Item Name: Fwd Crosstube - High 407

DART AEROSPACE LTD	Work Order:	124706
Description: Crosstube High Fwd (407)	Part Number:	D407-667-105
Inspection Dwg: D407-667-145 Rev: D		Page 1 of 1

DRAWING NO. D407-667-145	TITLE CROSSTUBE ASS'Y (407 HIGH FWD)	REV. C	DART AEROSPACE LTD ENGINEERING ORDER		D.E.O. NO. D407-667-145-C-1	SHEET NO. SHEET 1 OF 1	SCALE NTS
DRAWN 97	CHECKED ASS	MFG. APPR. IB	APPROVED MD		DE APPR. H		
DATE 11.07.15	DATE 11.07.22	DATE 11.07.22	DATE 11/07/22		DATE 11.07.21

DRAWING NO. D407-667-145	TITLE CROSSTUBE ASS'Y (407 HIGH FWD)	REV. C	DART AEROSPACE LTD ENGINEERING ORDER	D.E.O. NO. D407-667-145-C-2	SHEET NO. SHEET 1 OF 1	SCALE NTS
DRAWN AJS	CHECKED	MFG. APPR.	APPROVED	DE APPR.		
DATE 12.08.02	DATE 12.08.02	DATE 12.08.02	DATE 12.08.02	DATE 12.08.02	DATE 12.08.02

DETAIL P
BONDING STRAP INSTALLATION 2 PL

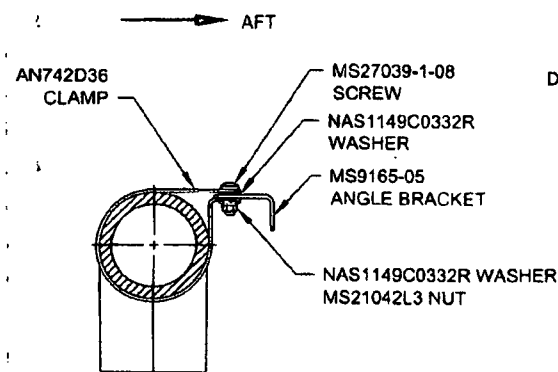
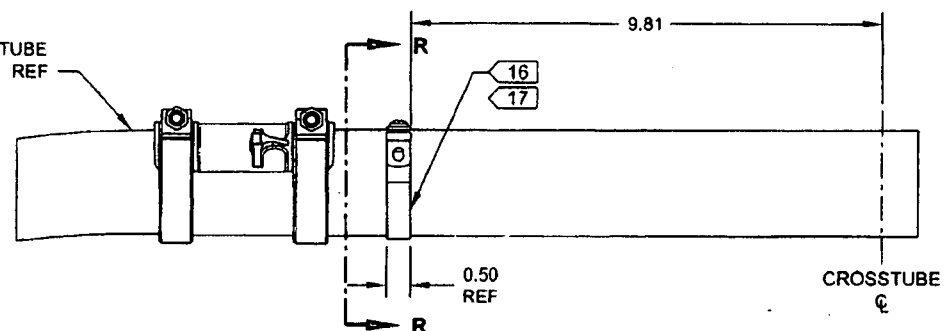
PURPOSE:

ADD ELECTRICAL GROUNDING STRAP

ITEM	QTY -145	PART NUMBER	DESCRIPTION
1	X	D407-667-145	CROSSTUBE ASSEMBLY (407 HIGH FWD)
10	2	AN742D36	CLAMP
11	2	MS9165-05	ANGLE BRACKET
12	2	MS21042L3	NUT (OR MS21042-3)
13	2	MS27039-1-08	SCREW
14	4	NAS1149C0332R	WASHER (OR AN960C10L)

- 16) MASK AREA UNDER CLAMP PRIOR TO PAINTING
- 17) SEAL EDGES WHERE AN742D36 CLAMP MEETS WITH THE CROSSTUBE USING SIKAFLEX-241/-291 OR MIL-S-8802 CLASS B2 OR PROSEAL 890 SEALANT
- 18) PERFORM RESISTANCE CHECK TO ENSURE MAX RESISTANCE IS 10 MILLIOHMS
